## **Appendix D: Historic and Cultural Resources**

D-1 Amended Finding Documentation, December 17, 2015

Re: FHWA  
Tappan Zee Hudson River Crossing Project  
Shared Use Path Facilities and Bicycle Pedestrian Connection Amended Finding  
Documentation-Retaining Wall Stone Cladding Information  
11PR06692

**Section 106 Review: Amended Finding Documentation**

Figure 1 Retaining Wall with Stone Cladding

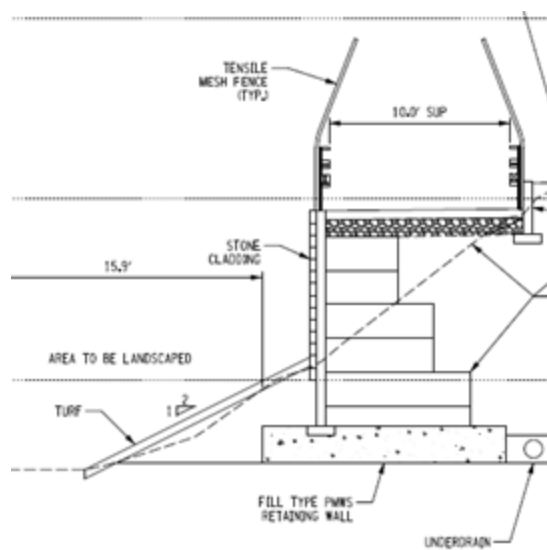
In response to your letter dated December 29, 2015, we offer the following additional information to clarify the proposed treatment of retaining walls, as described in the Amended Finding Documentation.

Natural stone cladding, defined as traditional stone facing laid-up along the exposed concrete face of the walls, will be provided on the retaining walls, which are to the east of the South Nyack Village Hall. Additional vegetation will be provided to screen the retaining and noise walls in the vicinity of the Village Hall to the maximum extent practicable. The precast noise wall panels replacing the existing wooden noise barrier will have a form liner with a stone pattern, and will be behind the proposed vegetation.

Natural stone cladding will be provided on the retaining walls in the vicinity of the South Nyack Village Hall. The existing wood noise barrier and vegetation will remain to the immediate west of the Village Hall.

Attached for your review, please find a drawing of the proposed treatment for the retaining walls.

Thank you for providing additional information as requested in my last letter. Based on a review of this new material, the NYSHPO has no additional concerns regarding the choice of material proposed for the SUP walls.
